REPORT ON DOE HANFORD TANK WASTE CLASSIFICATION

**Nuclear Regulatory Commission
Contract NRC-02-93-005**

**Center for Nuclear Waste Regulatory Analyses
San Antonio, Texas**

February 1997

Figure 2-1. Estimate Hanford Site Tank Waste Radionuclide Inventory^{c,d}

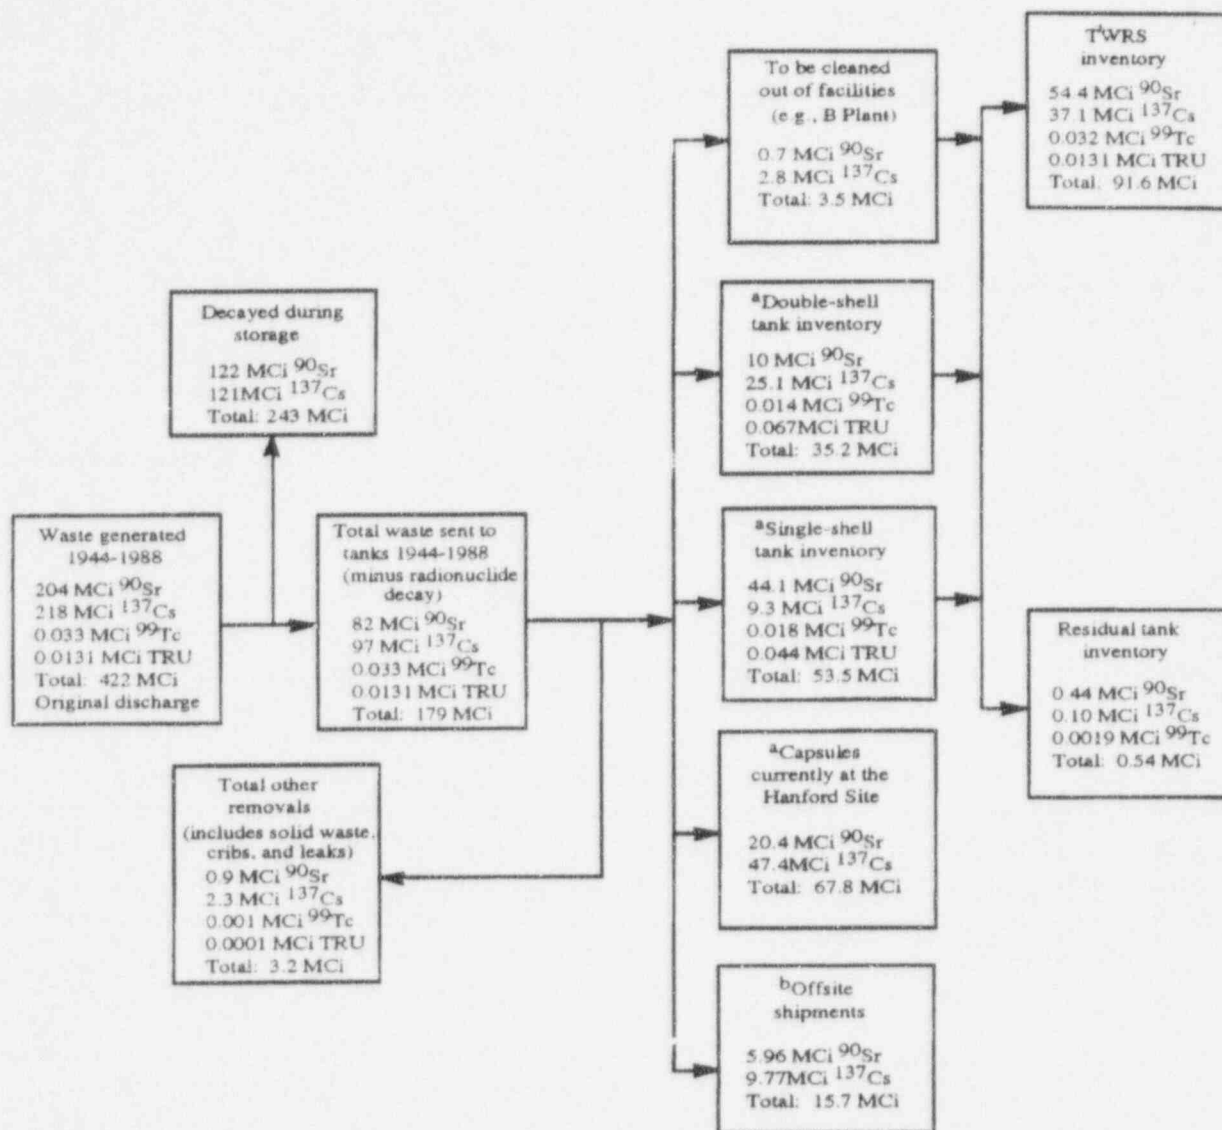
Figure 2-1, reproduced from the TBR (Westinghouse Hanford Company, 1996a, p. 3-2, figure 3-1), provides the estimated material balance for the Hanford Site tank waste radionuclide inventory. Figure 2-1 indicates that 243 MCi of the original tank waste radionuclide content of 422 MCi will have decayed by the year 1999. This value reflects the relatively short half lives of ^{137}Cs and ^{90}Sr . The material balance also indicates that approximately 87 MCi are accounted for as (i) leaks or deliberate discharges, (ii) encapsulation of ^{137}Cs and ^{90}Sr , (iii) other offsite shipments, or (iv) residual tank inventories. The remaining 91.6 MCi consists of 55.6 MCi insoluble waste to be disposed in a geologic repository as HLW and 36 MCi that comprises the soluble radionuclides that will be further treated to produce what DOE proposes to classify as incidental waste. This 36 MCi contains most of the ^{137}Cs and ^{99}Tc and almost all of the ^{79}Se , ^{129}I , ^{14}C , and ^3H (Westinghouse Hanford Company, 1996a, p. 4-1). After further treatment, 8.5 MCi will remain as incidental waste with 27.5 MCi being added to the HLW stream.

As shown in figure 2-1 of this report, 91.6 MCi comprises the Hanford Site tank waste inventory that will be processed for disposal as HLW or LLW. Approximately 99.9 percent of this waste is ^{137}Cs or ^{90}Sr . Initially, a simple solids-liquids separation will be performed on this waste to yield a low-activity liquid fraction containing the bulk of the nonradioactive materials, including about 3 percent solids carryover, and a high-activity fraction containing most of the solids. This solids-liquids separation process is expected to be relatively simple to complete and will remove approximately 55.6 MCi, consisting primarily of ^{90}Sr and TRU radionuclides (Westinghouse Hanford Company, 1996a, pp 3-2, 4-1, 4-2). Chapter 5 of the TBR concludes that, with the additional selective removal of transuranic wastes from three complexant concentrate tanks, and single-cycle ion exchange removal of ^{137}Cs from certain wastes,
